1979 Corvette: Service News: Corvette Auxiliary Cooling Fan Wiring Revision

Model and Year: 1979 Corvette Equipped with 5.7L (350 Cu. In.) V-8 RPO L82 and Air Conditioning

Source: Chevrolet Service News

Fig. 4 — 1979 Corvette Auxiliary Cooling Fan Wiring Diagram

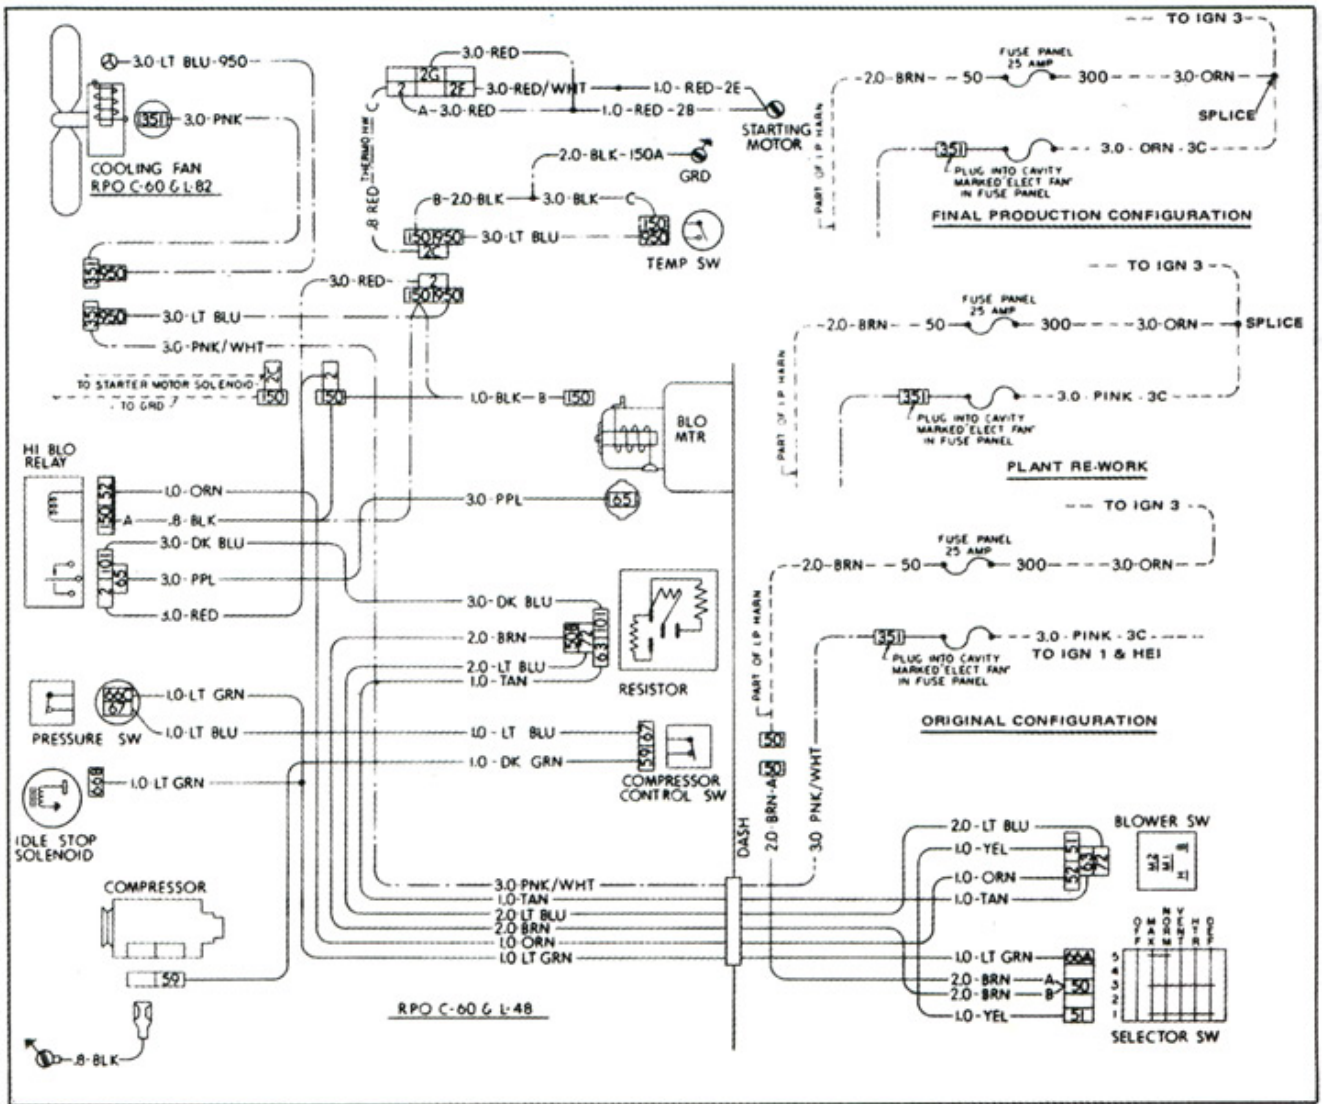
During early production, it was discovered that non-powered rundown of the fan motor generated a voltage sufficient to maintain ignition after ignition switch shut-off. This could result in a momentary engine run-on condition similar to dieseling.

To eliminate any run-on, the assembly plant began re-working the instrument panel wiring harness, effective with VIN 1Z8749S402690, as shown in the wiring diagram (see Figure 4). A final production revision to the harness (see diagram) will be phased into production as soon as possible.
